MIL-P-63234(AR)
AMENDMENT 3
12 JULY 1989
SUPERSEDING
AMENDMENT 2
8 June 1983

MILITARY SPECIFICATION

PROJECTILE, GUIDED, 155MM, XM712
ROLL RATE SENSOR FOR

Figure 1. Timing Sequence

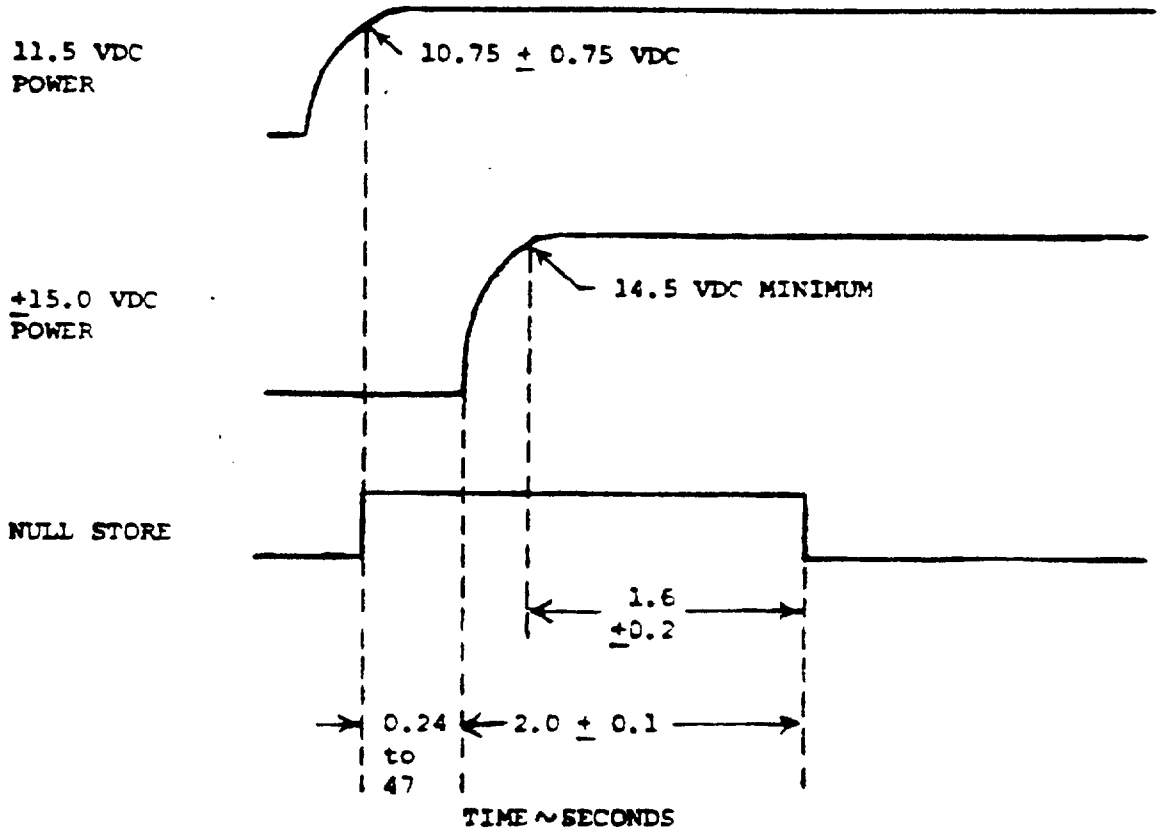
"4.5.3.3.1 Gross operating vibration.- The RRS shall be tested while operating during vibration per MIL-STD-810C, Method 5142, Procedure V, Part 2, Curve AF of Figure 514.2-5 at 7.6 g RMS. Power shall be applied per Figure 1 with the exception of the null store time which shall be 3.0 $\pm$ 2.0 sec instead of 1.6 $\pm$ 0.2 sec.

"4.5.3.3.2 Performance vibration.- The RRS shall be tested while operating with power application per Figure 1 during vibration per MIL-STD-810C, Method 514.2, Procedure V, Part 2, Figure 514.2-5, Curve AF except at 2.4 g RMS."

Replace Figure 1 with new Figure 1 attached.

FIGURE 2. Roll Rate Output Boundaries

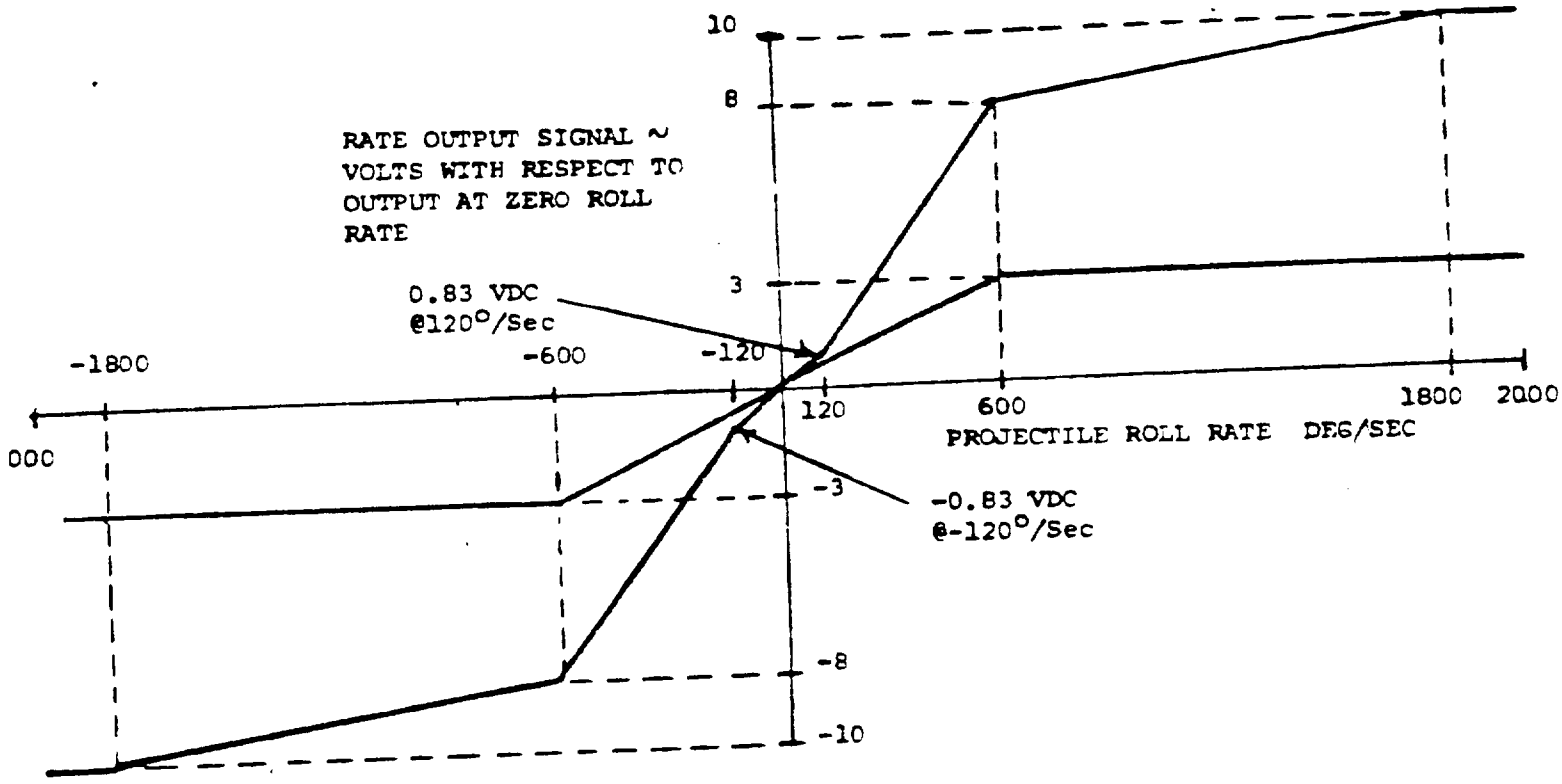
Replace Figure 2 with new Figure 2 attached.

Figure 4. Command Signal Drift Rate Boundaries

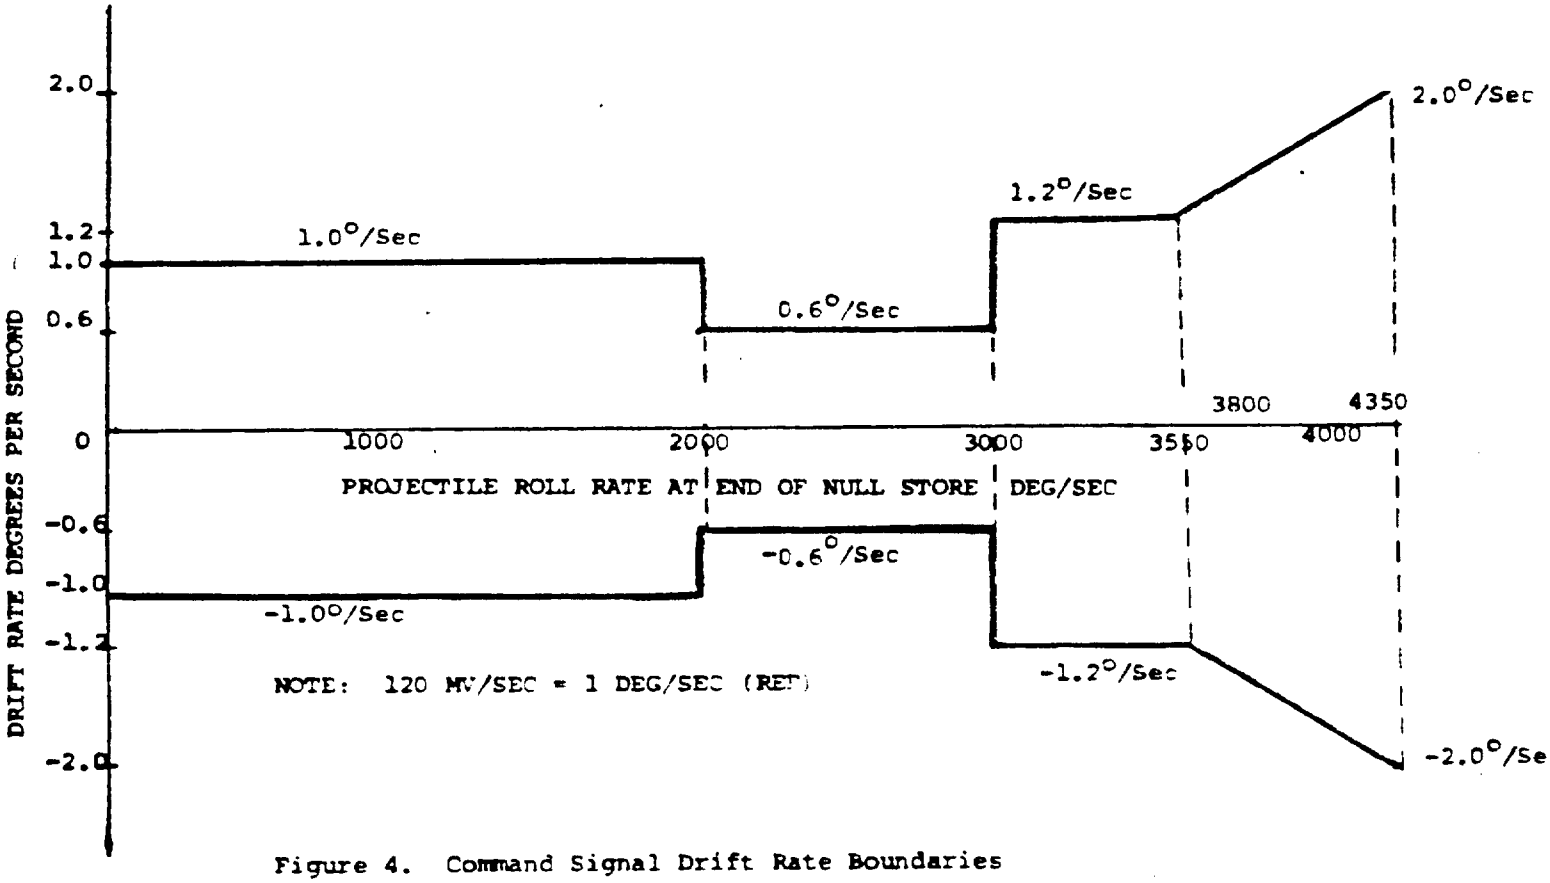
Replace Figure 4 with new Figure 4 attached.
